April 25, 2025

Blue Jay Point County Park - Renovation Wake County

ADDENDUM #3

C - 104

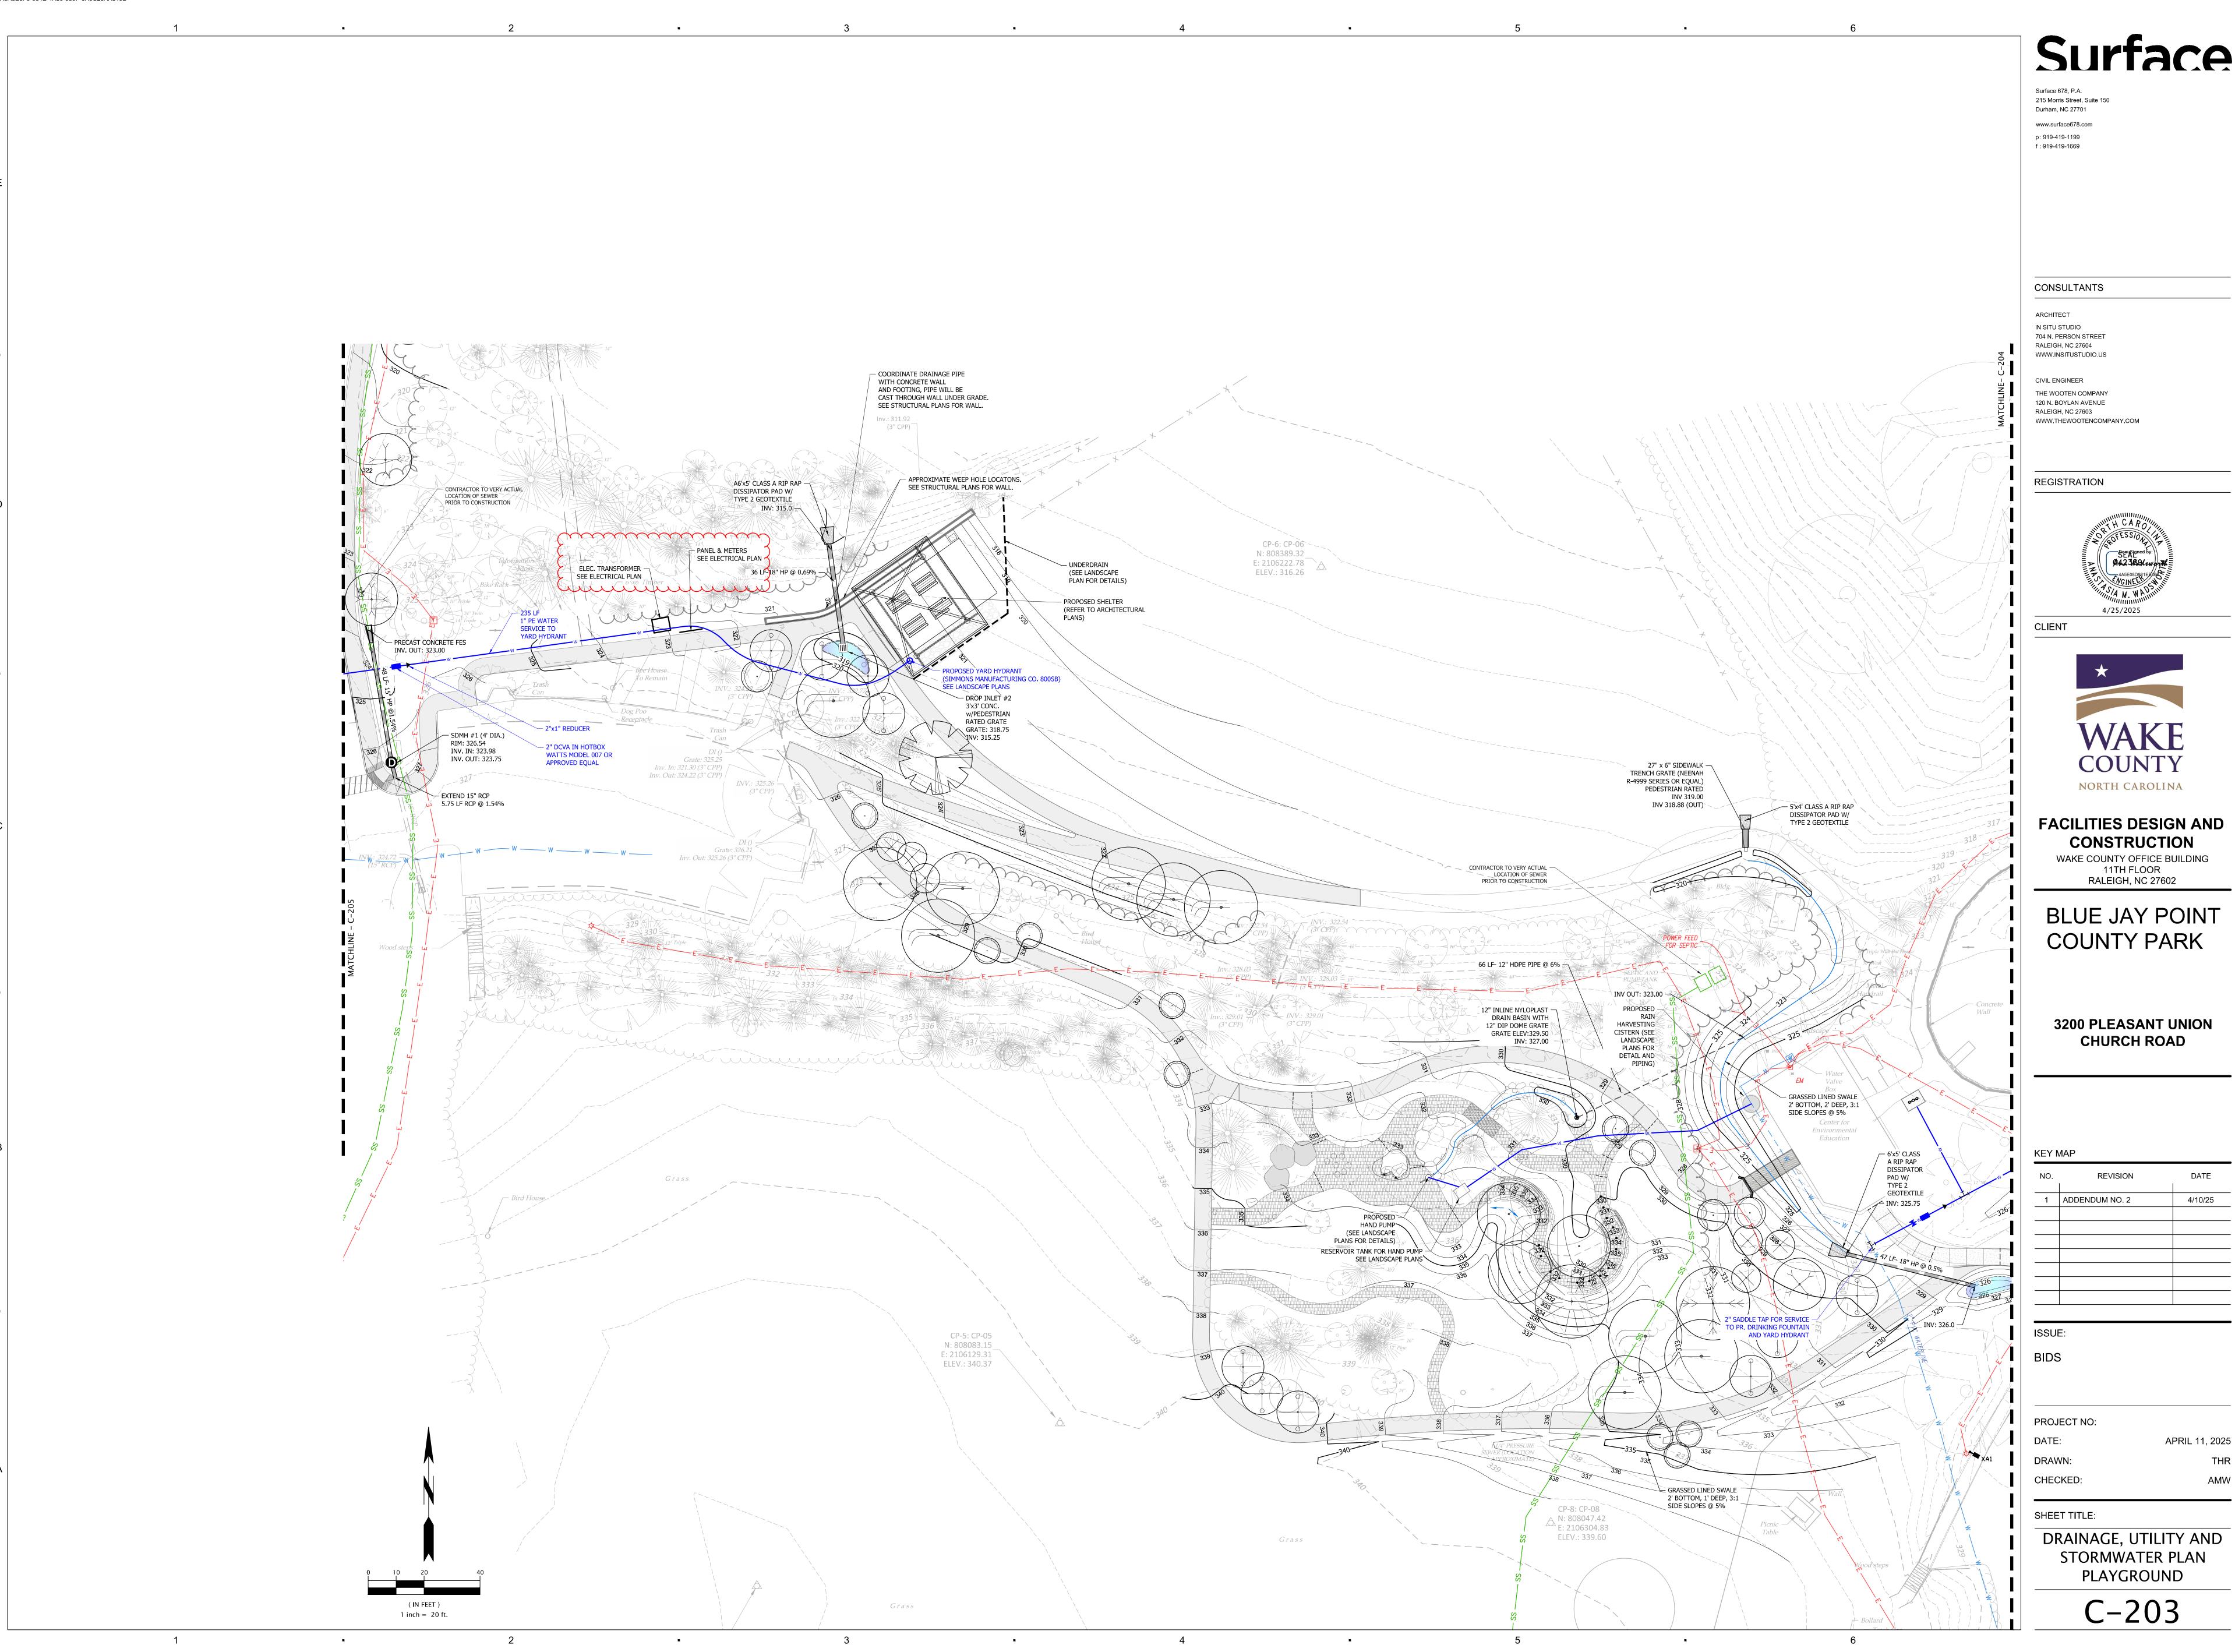
- 13. Demo: Just a note that your match lines overlap on a lot of the plan sheets, is it possible to make all the match lines actually match up to make our take off much easier to get the correct quantities. If you look at C103 to C104 there is quite a bit of overlap.

- 14. Demo: On page C104 who is responsible to relocate existing electric within the limits of work?
 - Contractor will be responsible for coordinating with Duke Energy on relocation of lines

- 15. Demo: On page C104 do we remove asphalt parking lot as shown in red outlined and hashed?
 - a. Response: Yes, per the legend, the cross hatch is shown as hardscape to be removed. The dual diagonal line hatch represents pavement that is to be milled. Notes are shown on this sheet for what is to be sawcut vs milled.

- a. Response: This appears to be the only sheets where overlap is more evident. There is not much detail that is duplicated on both sheets 103 and 104. At this time, we prefer not to update the plans.

C-204

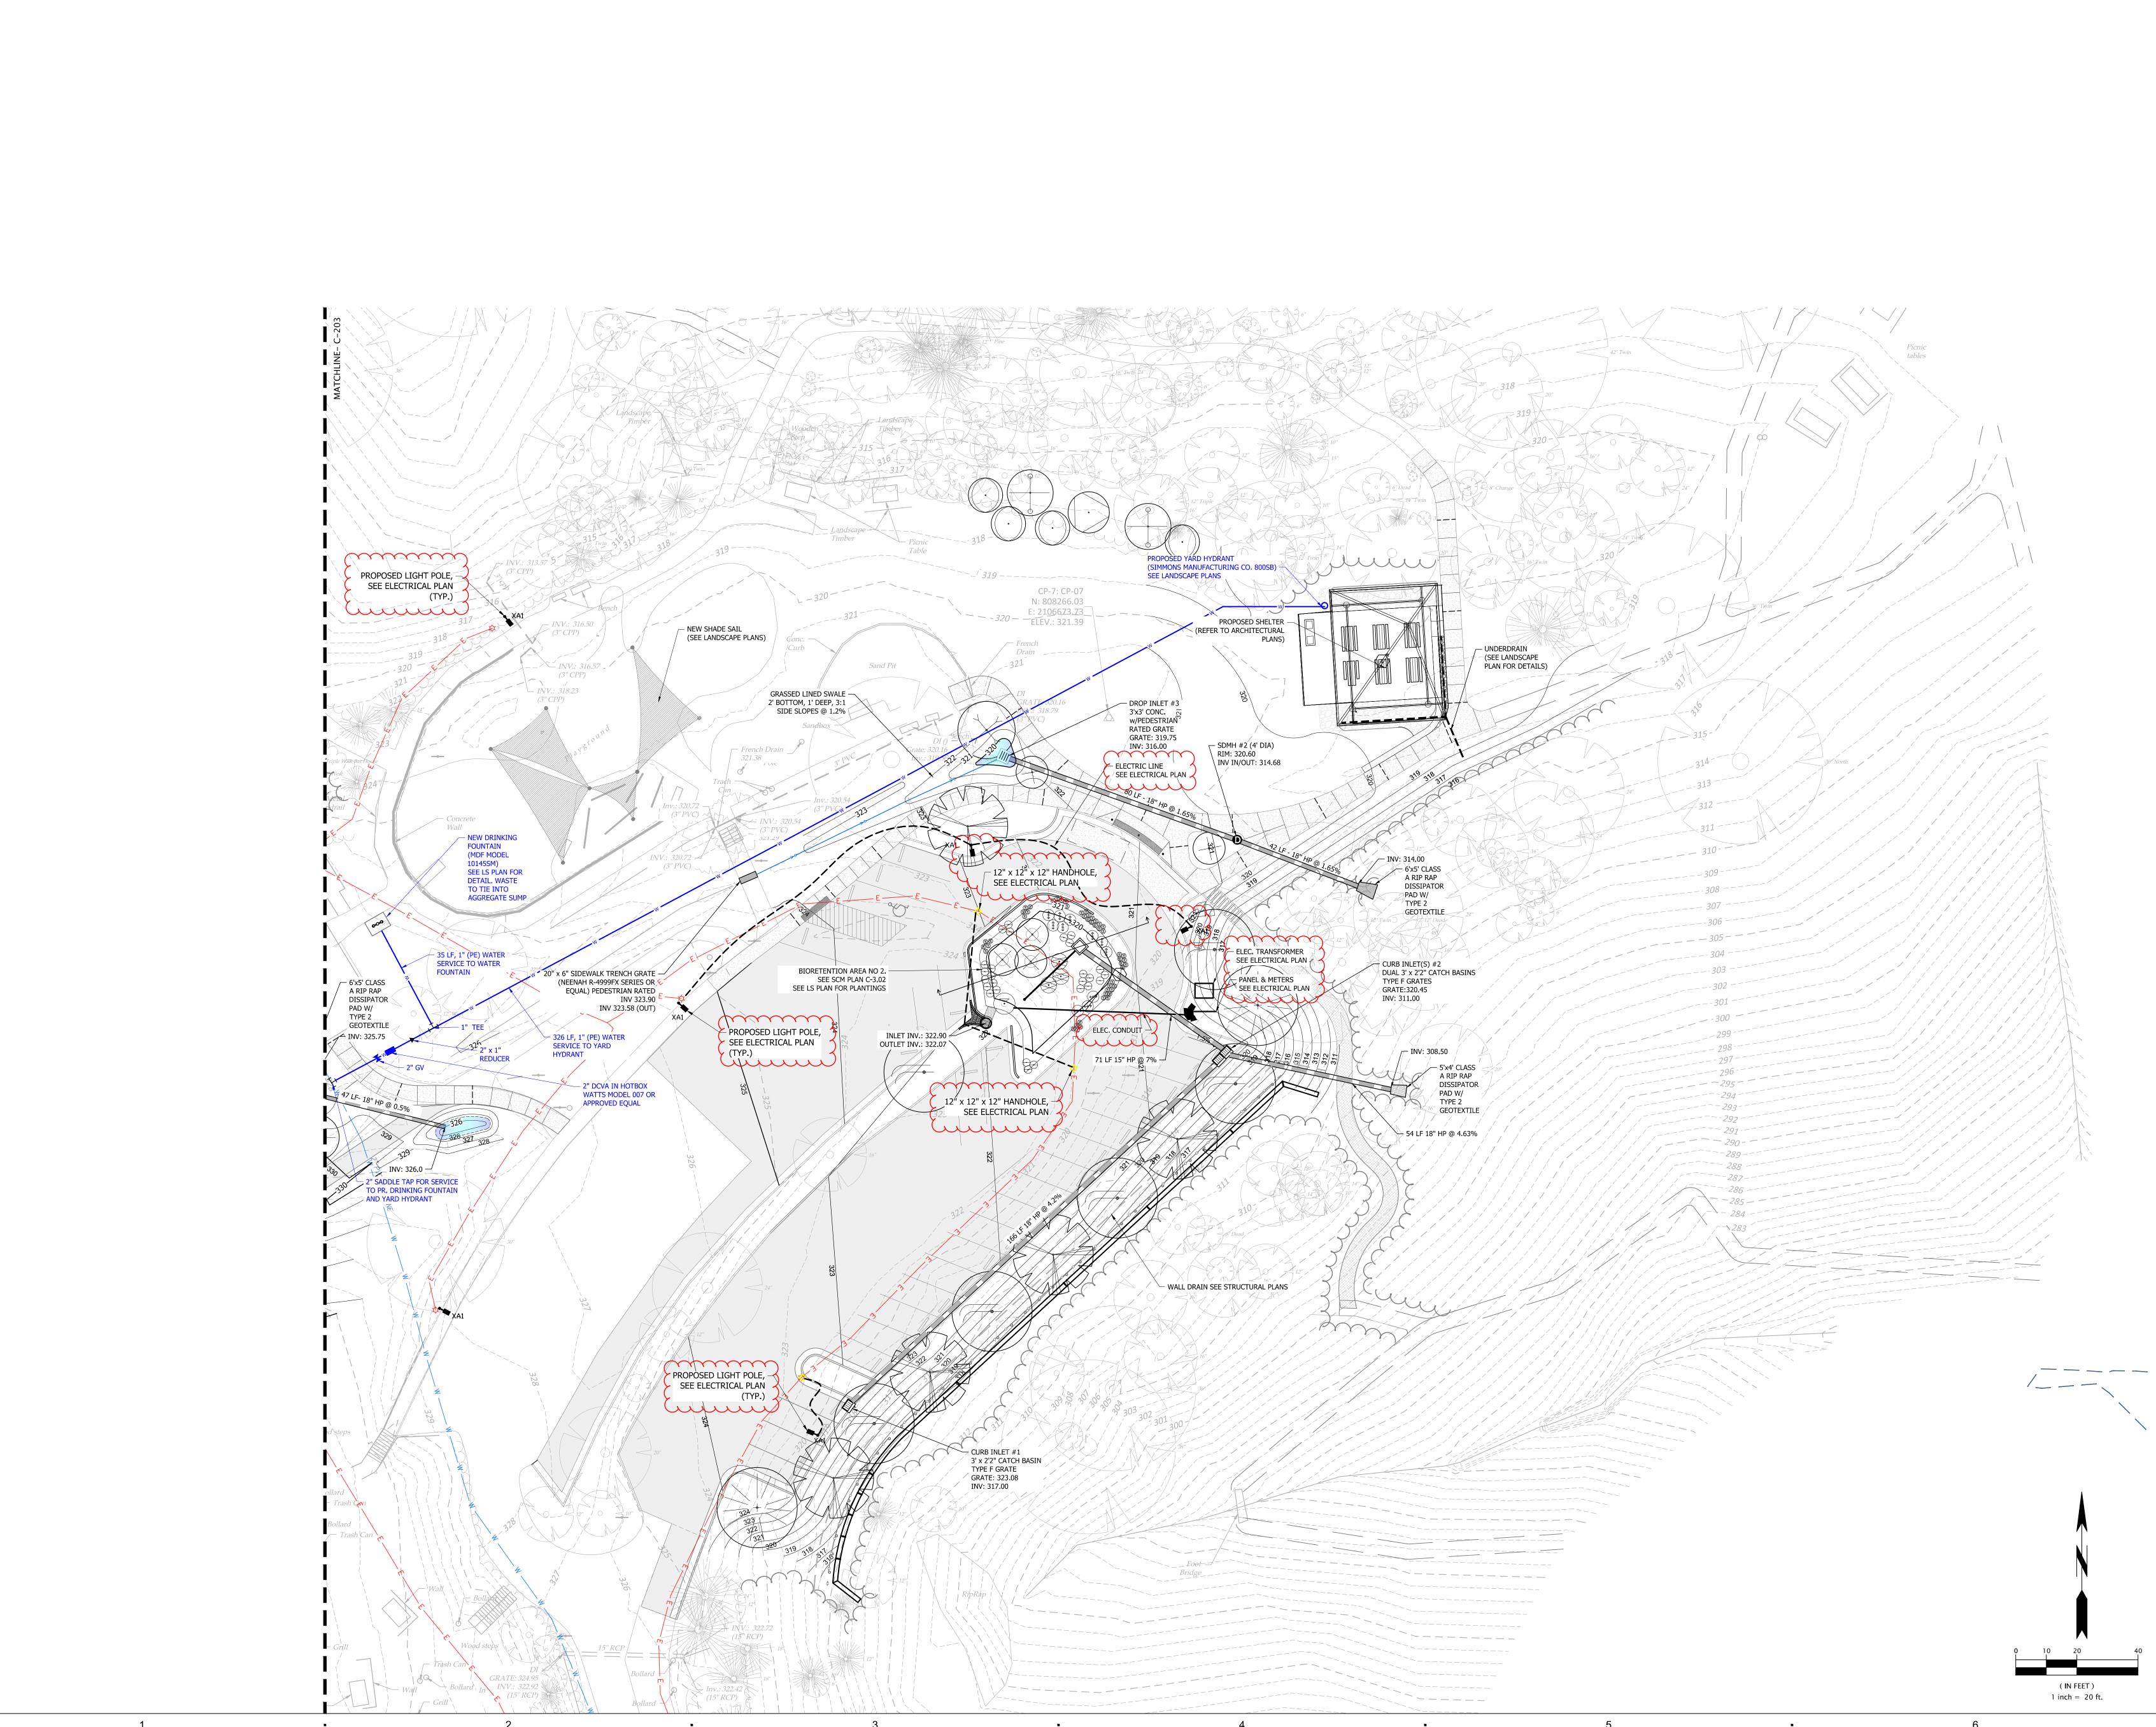
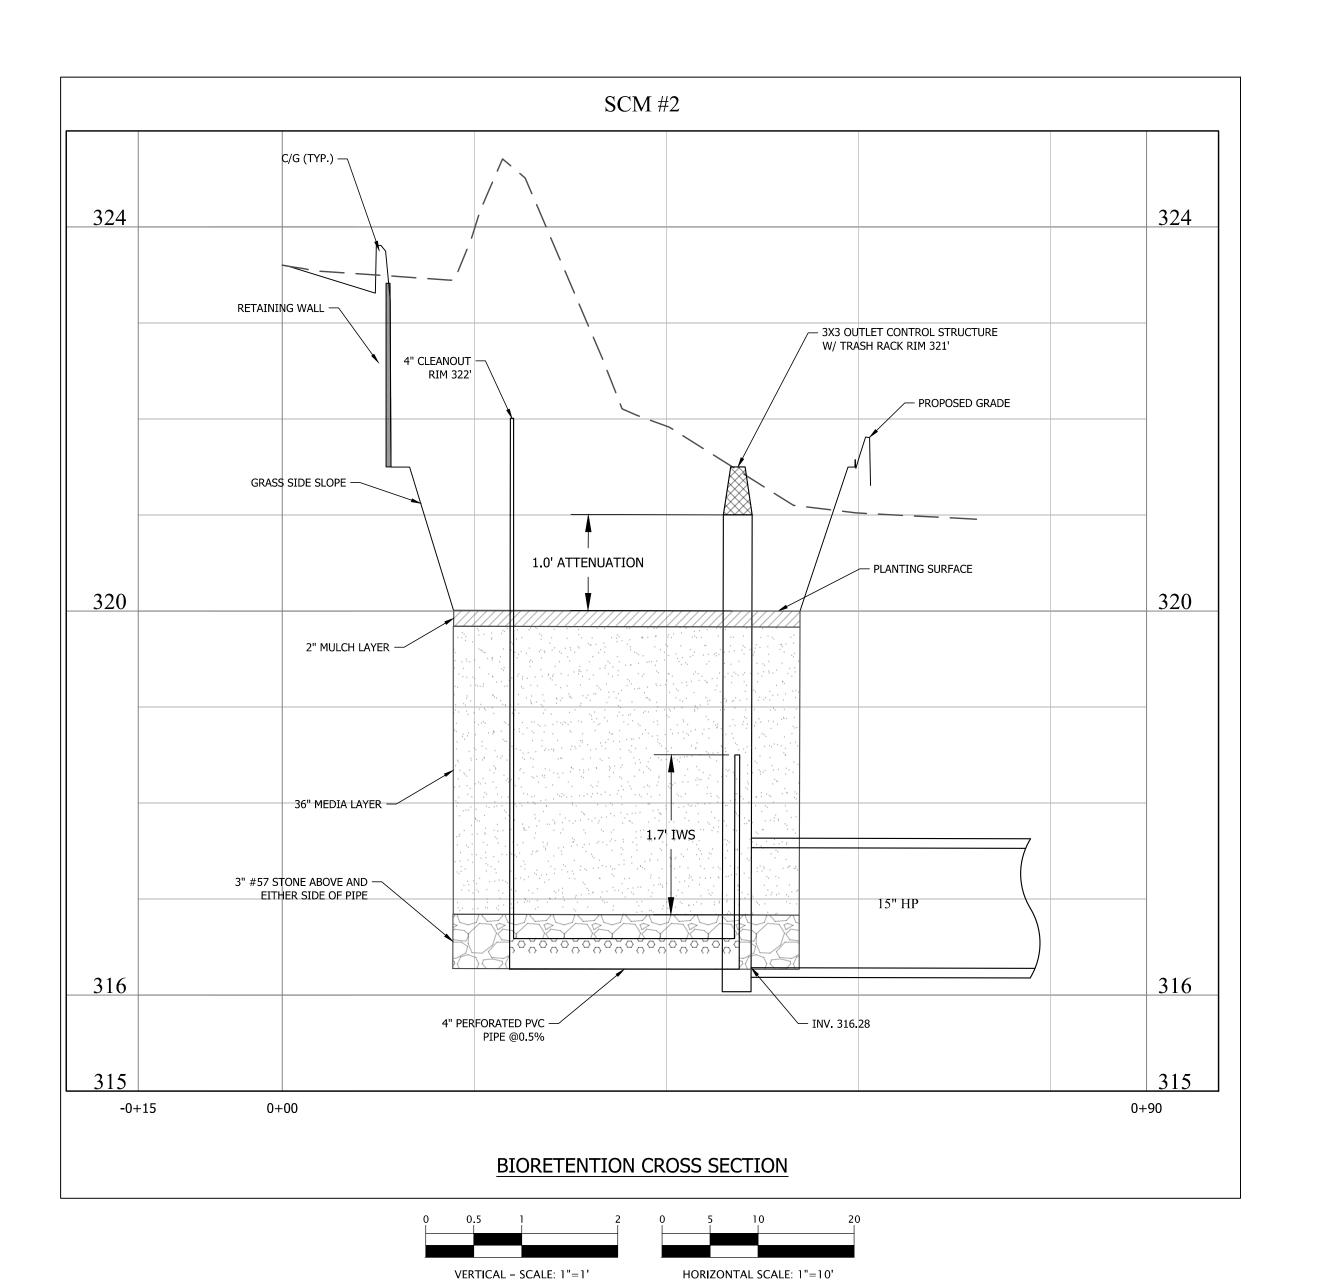
- 1. L134 Revised curb layout
- 2. L138 Revised curb ramp
- 3. L161 Revised mulch areas and planting legend.
- 4. L162 Revised planting legend.
- 5. L163 Revised planting legend.
- 6. L164 Revised planting legend.
- 7. L165 Revised planting legend.
- 8. L166 Revised planting legend.
- 9. L167 Revised planting legend.
- 10. L168 Revised planting legend.
- 11. L169 Revised planting legend.
- 12. L501 Revised detail B1 Slate Pavers on Concrete Base
- 13. L506 Revised detail A2 Fixed Bollard
- 14. C-104 Notes added to existing light fixtures
- 15. C-201 Adjusted drop inlet
- 16. C-203 Added electrical linework
- 17. C-204 Added electrical linework
- 18. C-302 Added electrical linework
